STAFF REPORT: OCTOBER 8, 2025 MEETING

APPLICATION NUMBER: HDC2025-00129

ADDRESS: 863 IROQUOIS (A.K.A. MARTIN S. SMITH II HOUSE)

SCOPE: REPAIR/REPLACE LIMITED TRIM AND STUCCO, REPLACE FRONT PORCH COLUMN, REPLACE RIBBON DRIVE (WORK STARTED WITHOUT APPROVAL)

863 Iroquois, front (east) façade, September 2025, staff photo. Column is missing and vinyl corner boards have been installed.

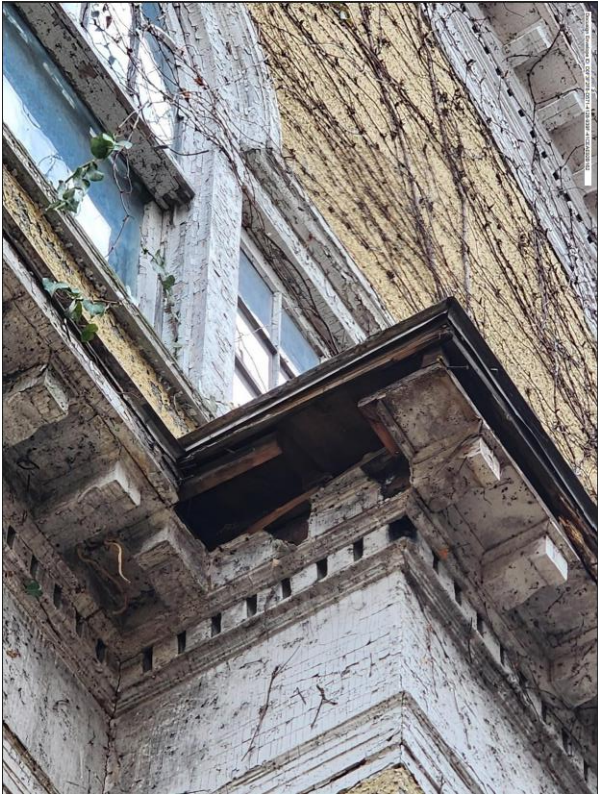
863 Iroquois, Detroit Parcel Viewer. It appears that the dormers are roofed in copper. The roof work permitted in May specifically excluded work on the dormers.

Applicant's photo, April 2025. Southeast corner corner board, partially removed. The elaborate trim details and ornate windows are visible here on the house's south side.

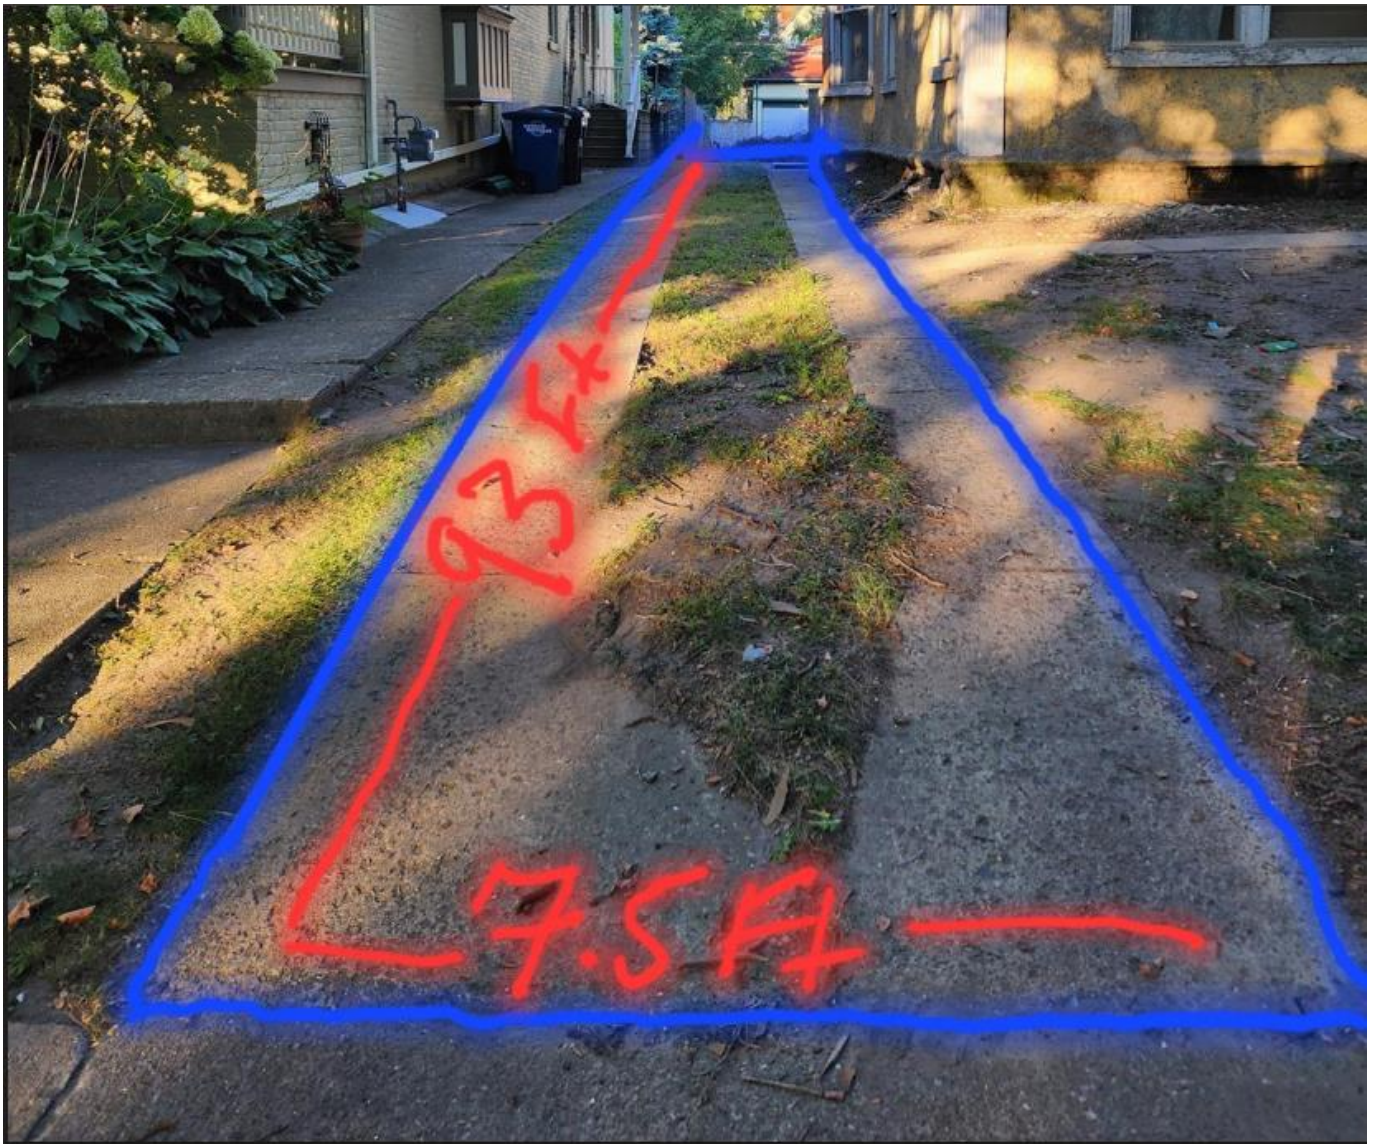
Applicant's photo, April 2025. Porch column half removed, base is in poor condition. Newel post visible to support the handrail for the steps.

Applicant's April 2025 photos of the walkway and driveway where concrete removal and new concrete installation are proposed. The limestone front porch steps were initially included in the April scope of work, and then the applicant indicated in a later clarification (May 5 2025, Cycle 3) that they would instead be preserved.

Staff photo, September 2025, northeast corner with vinyl corner board and north side visible.

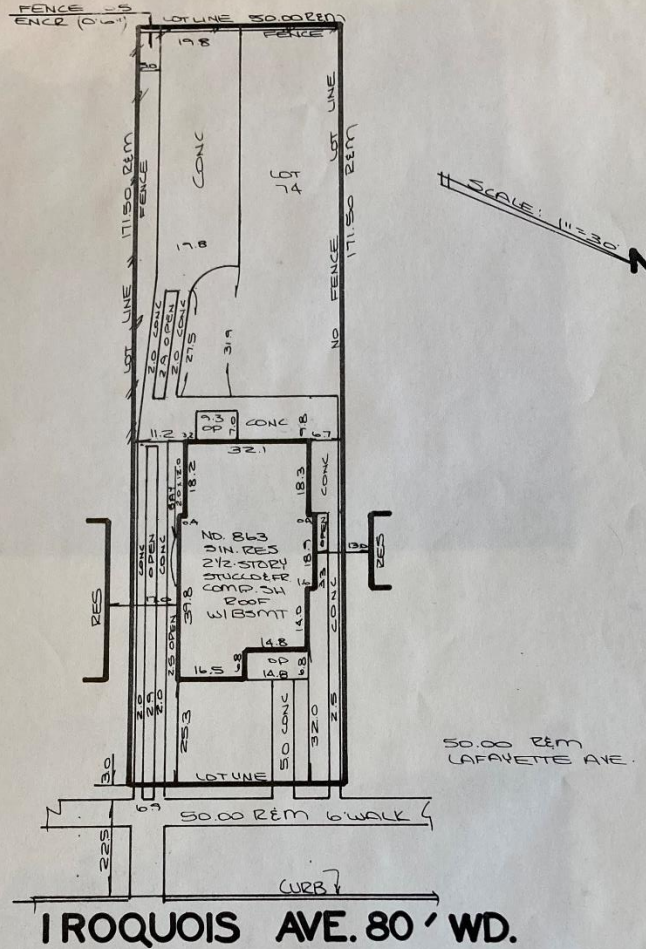
- Regarding the vinyl pilasters being proposed as corner boards, the Secretary of the Interior's Standards for Rehabilitation require that the corner boards that had been in place should have been repaired if possible, and if repair was not possible, they should have been replaced in kind as close as possible in design, color, texture, and, if possible, materials. (An alternative approach the Standards and Guidelines would allow could have been that the quoining at the corners shown in 1979 photos could have been restored, but that is not the submitted proposal.) The submitted proposal is to use vinyl trim to replace the wood. The trim that had been in place was compatible with the pilasters and column on the front porch and was a continuous 23 feet from top to bottom (see photo below), with fluting from the decorative cap to the decorative base. The proposed (installed) material is not compatible with wood because of its texture and sheen. The proposed (installed) design is not compatible because instead of continuous fluting from cap to base, the proposed is two pieces of trim instead of one, so there is a cap and base on top of a cap and base. That is not an adequate in-kind replacement of the material that was there. The vinyl is incompatible with this historic house and does not meet the Standards (1) because of its incompatible texture and sheen, (2) because the limits in available sizes of the material necessitates a historically incorrect installation and design, and (3) because vinyl is not a traditional material contemporary with the period of significance.

Applicant's photo of previous corner boards with continuous fluting from cap to base (left, from Cycle 4 materials), compared with the vinyl trim now installed that has the fluting interrupted by an extra base and cap midway (right, staff's September photo). The vinyl's sheen and texture are also incompatible, and it appears to meet the stucco differently than the wood trim had previously. There appears to be an extra seamed band of trim over the nearby stucco that was not there before.

- The vinyl corner board trim pieces at the northeast and southeast corners of the house will be removed and replaced with trim that is compatible for the house and meets the Standards. The applicant will submit a replacement corner board proposal to staff for review and approval before the certificate of appropriateness is issued.
- A dimensioned drawing of the porch guardrail and handrail for the steps (if one is proposed) will be submitted to staff for review and approval before the certificate of appropriateness is issued.
- The ribbon driveway will be retained. The concrete may be replaced, but the driveway's form as two ribbons of concrete with dirt between and on either side to support grass must be retained. An updated site plan and quote/contract for the work will be submitted to staff before the certificate of appropriateness is issued.
